**Multiple Sewershed Package 14 – CIPP
Solicitation No.: CO-00364
Job No.: 19-4513**

**ADDENDUM 2
November 3, 2020**

MAP No. 000-000	SHEET 46 OF 71	
SECT. No.		
DR. JFM	CK. JGM	JOB No.

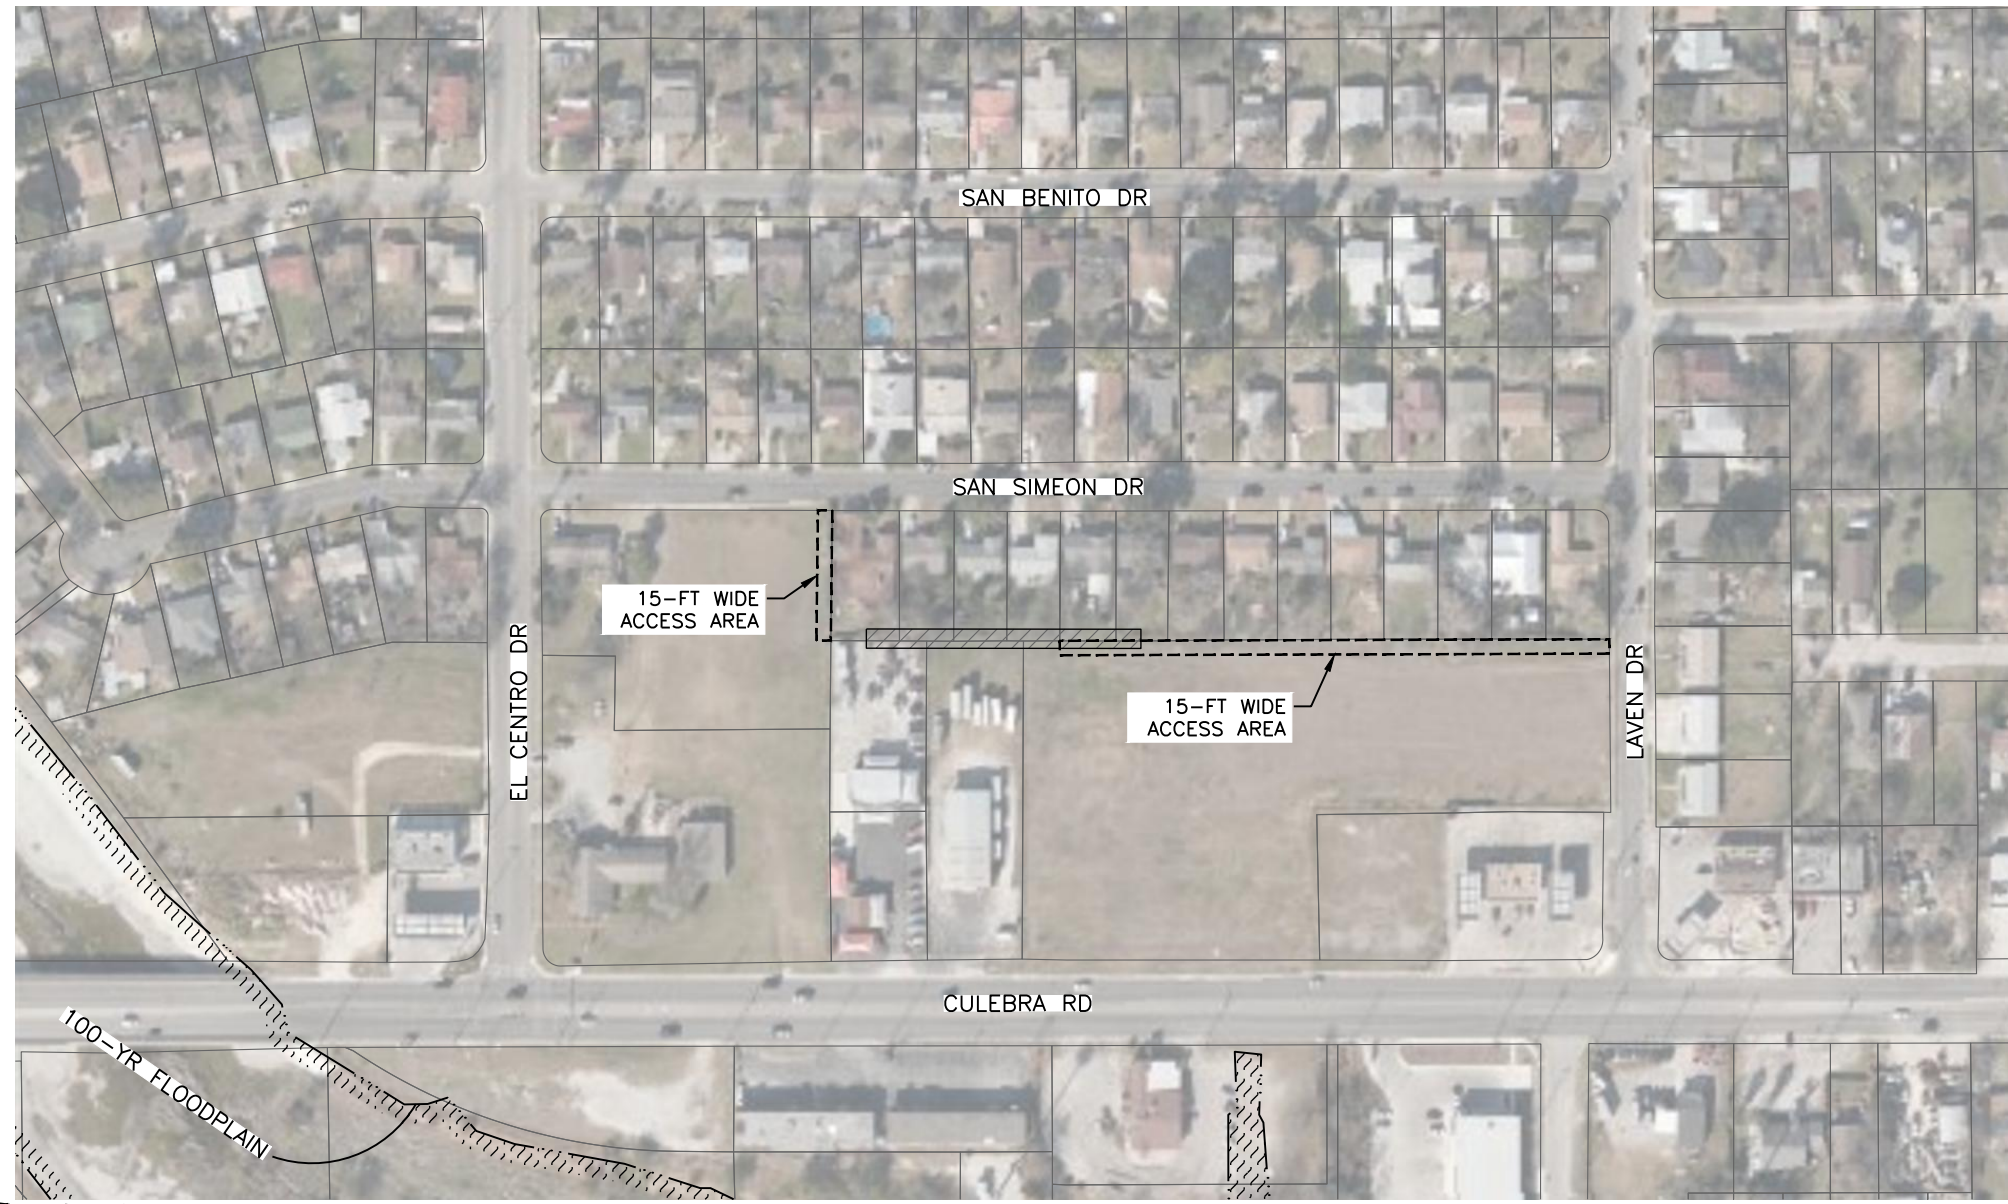
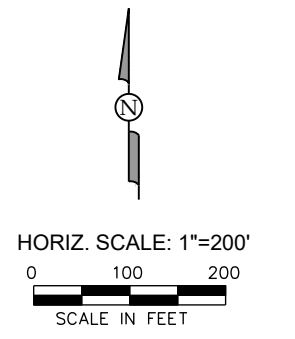
- 3. Question: There are no bid items for traffic control for Sites 10, 13, & 14. Should there be?**

Response: A Traffic Control Plan is not required for Sites 10, 13, and 14. Refer to Sheet 46, 56, and 59.

TCP NOTE:
NO TRAFFIC CONTROL REQUIRED
